SAFETY EVALUATION REPORT

DESIGN MODIFICATION ON LPCI SWING BUS TRANSFER SCHEME

QUAD CITIES UNITS 1&2/DRESDEN UNITS 2&3

DOCKET NO. 50-254/265 & 50-237/249

FIGURE -1

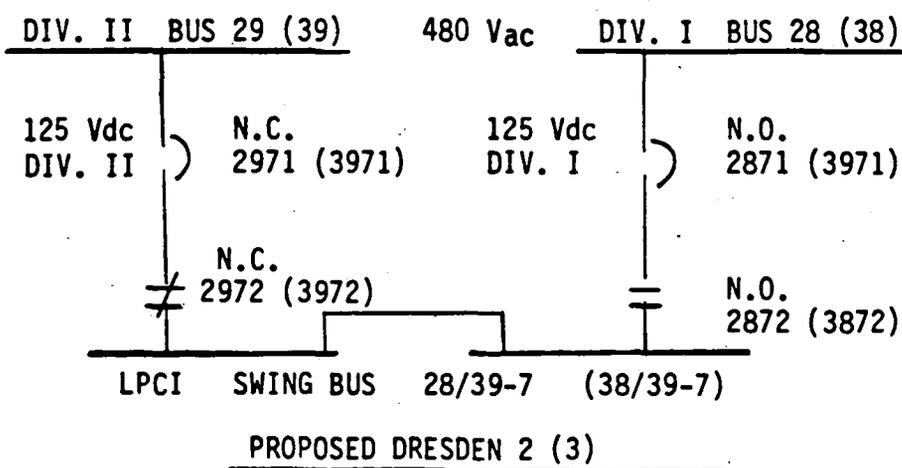
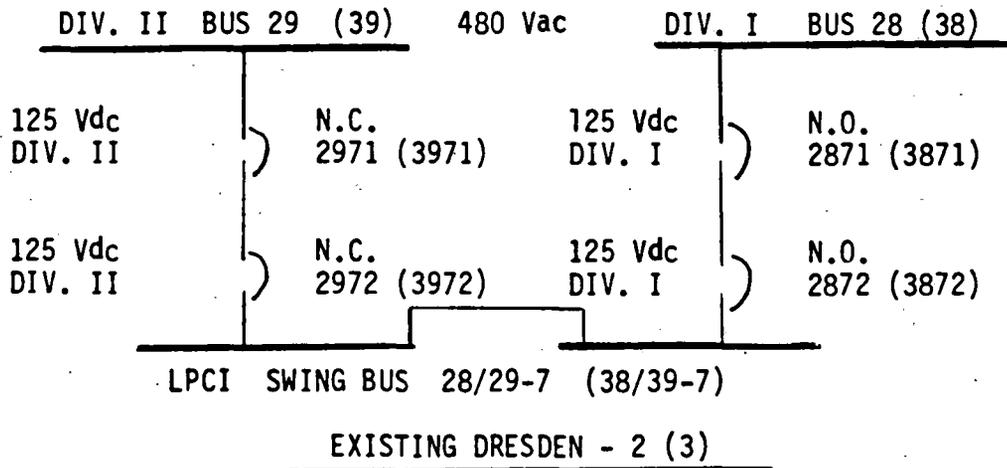
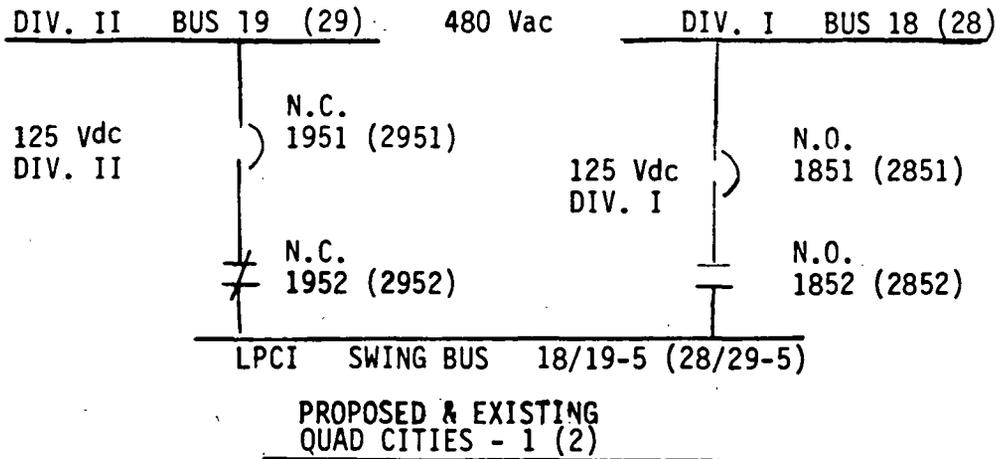
The existing 480V LPCI swing bus design for Quad Cities and Dresden (See Figure-1) is normally fed from Division II via two in series interrupting devices; Quad Cities uses a circuit breaker and contactor while Dresden uses two circuit breakers in series. Upon loss of the normal feed, the bus automatically transfers to its Division I Standby Alternate 480V power source. This is accomplished upon sensing under-voltage from the normal 480V source (Division II) for longer than 15 seconds. The auto bus transfer for each plant is accomplished as follows: For Quad Cities Units 1 (2), normally closed contactor 1952 (2952) opens on sensing under-voltage and normally closed breaker 1951 (2951) is tripped open from the normal 480V power source by using DC control power from the Division II battery. Upon expiration of the 15 sec time delay, the transfer to the Alternate 480V Division I (Bus 18) takes place by closure of both the normally open circuit breaker 1851 (2851) and contactor 1852 (2852) by using DC control power from the Division I battery.

The Dresden Unit 2 (3) existing design (See Figure-1), has a normally closed circuit breaker 2971 (3971) which is tripped open along with circuit breaker 2972 (3972) by utilizing DC control power from the Division II battery. Then, the transfer to the Alternate 480V Division I (Bus 28) power source is completed by closing both normally open circuit breaker 2871 (3871) and circuit breaker 2872 (3872) by utilizing DC control power from the Division I battery.

Interlocks are provided for each interrupting device (i.e., breaker or contactor) within a division and between redundant divisions. Thus, to complete the transfer, the design requires 125V DC control power from the Division II battery to open and Division I battery to close all the necessary circuit breakers or contactors to complete an automatic transfer. In the event of a DC failure in either division (i.e., battery or control power), the auto transfer will be blocked.

With the existing design deficiency, certain abnormal plant conditions (within the required design basis) could result in a failure of the automatic transfer function from energizing the swing bus which supplies power to all of the LPCI flow control valves (i.e., total loss of LPCI capability). For example, if a LOOP de-energized 480V AC Bus 19 (Division II) coincident with a loss of Division II 125V DC control power (due to a single failure) the swing bus would become de-energized without the ability to transfer automatically. A detailed sequence of events would be as follows (refer to figure-1): 1) LOOP creates an under voltage condition on the LPCI swing bus, 2) 480V AC Bus 18 (Division I) output-breaker (1851) attempts to close and re-energize swing bus as part of automatic transfer scheme, 3) Interlocking contact 1951/a immediately trips breaker 1851 open because the Bus 19 output breaker (1951) is still closed (failed closed due to loss of Division II control power), and 4) Bus 19 (consequently the LPCI swing bus) remains de-energized since Division II control power is also necessary to start the diesel generator to load onto Bus 19 during a LOOP. However, this deficiency in the swing bus automatic transfer

scheme design can be corrected by removing auxiliary contact 1951/a from the trip circuit of breaker 1851 (Alternative I design). This design modification alters the aforementioned scenario by allowing breaker 1851 to remain closed (because interlock with breaker 1951 is removed) which energizes contactor 1852 to close and thus establish proper transfer. Once the transfer is completed (i.e., breaker 1851 and contactor 1852 closed), interlocks are provided to prevent breaker 1951 and contractor 1952 from closing. Therefore, with this modification in place there is no longer any reliance upon the Division II battery to accomplish the auto transfer, in effect correcting the design deficiency. The original AC power supply configuration may be returned to the preferred lineup by a manual control, when appropriate control and motive power sources are restored.

Although this design modification removes one of the two interlocks which protects against a cross-tie of redundant power sources, CECO has utilized breaker coordination in combination with the remaining interlock to protect against this occurrence. As previously mentioned the staff is reviewing the S&L study submitted by CECO in a letter dated May 13, 1988 (Study 2) to determine the adequacy of the breaker coordination between the feed breakers and the LPCI swing bus. The staff has determined that proper breaker coordination in combination with a single interlock is an acceptable alternative to the utilization of two interlocks.

We reviewed the licensee's proposed three alternative swing bus transfer schemes and determined that Alternative I is an acceptable design because it maintains:

- 1) Original transfer philosophy and licensing basis for the plant.
- 2) Original electrical separation criteria (i.e., no redundant DC division crosstie within a 480V AC division).
- 3) No reliance on Division II battery power to trip the circuit breaker 1951 prior to accomplishing transfer to the alternate source.
- 4) Interlock protection between two AC power divisions to prevent paralleling of redundant power sources.

Based on our review of the licensee's proposed LPCI swing bus transfer modification, which was designed to keep a failure of 125V DC control power (assumed to occur simultaneous with LOCA and LOOP) from precluding LPCI swing bus transfer, we concur with the Alternative I design proposal for both Dresden and Quad Cities units. We've concluded that it will correct the existing design deficiency and is acceptable.
